# Pentium® Processor Specification Update

Release Date: January 1999

Order Number 242480-041

The Pentium® processor may contain design defects or errors known as errata which may cause the product to deviate from published specifications. Current characterized errata are documented in this Specification Update.

### 2. **Incorrect TCP Pinout Drawing**

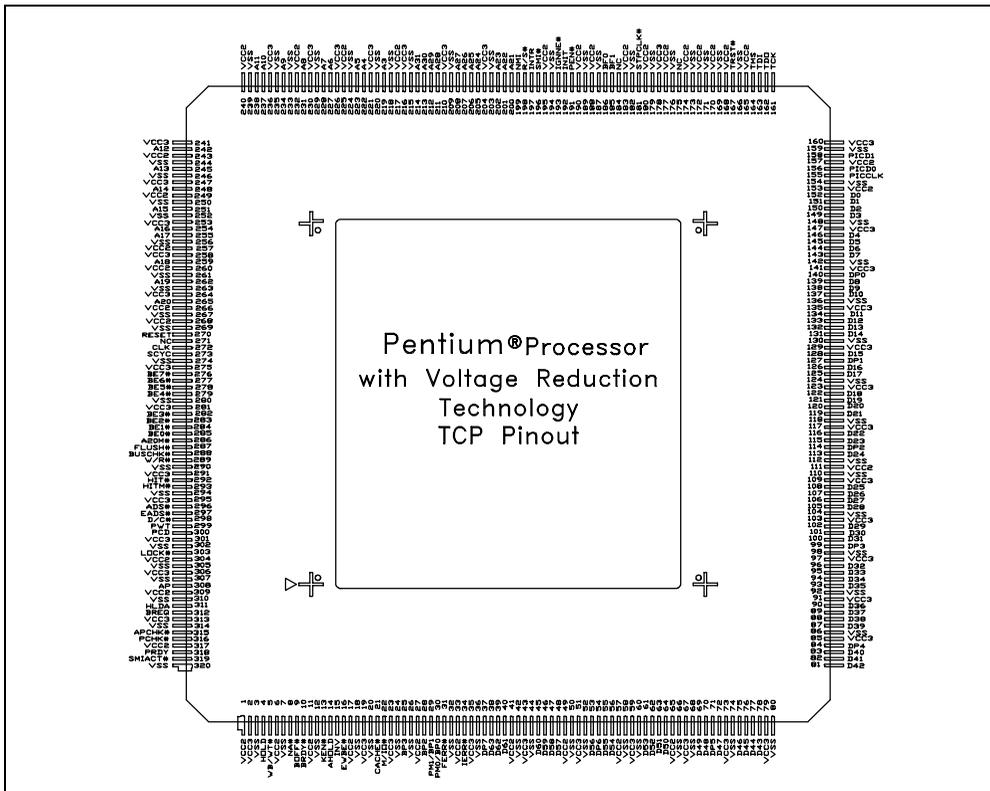
The TCP pinout drawing on page 8 of the *Pentium Processor with Voltage Reduction Technology* datasheet was inadvertently rotated. The correct orientation is shown below.

Figure14-1. Maximum Undershoot Level, Undershoot Threshold Level, and Undershoot Threshold Duration

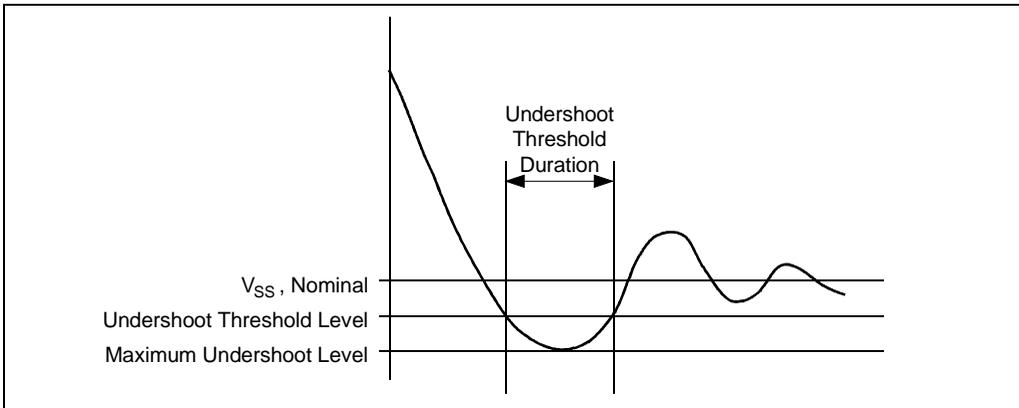
**MAXIMUM RINGBACK SPECIFICATION:** The maximum ringback of CLK associated with its low state (undershoot) must not exceed 0.8V as shown in Figure 14-1.

**UNDERSHOOT THRESHOLD DURATION SPECIFICATION:** A snapshot of the clock signal should be taken at 500 mV/div and 500 pS/div (for CLK). Adjust the vertical position and horizontal offset position to view the threshold duration. The undershoot threshold duration is defined as the sum of all time during which the clock signal is below -0.5V within a single clock period. The undershoot threshold duration must not exceed 20% of the period.

This undershoot specifications are illustrated graphically in Figure 14-1 and Figure 14-2.
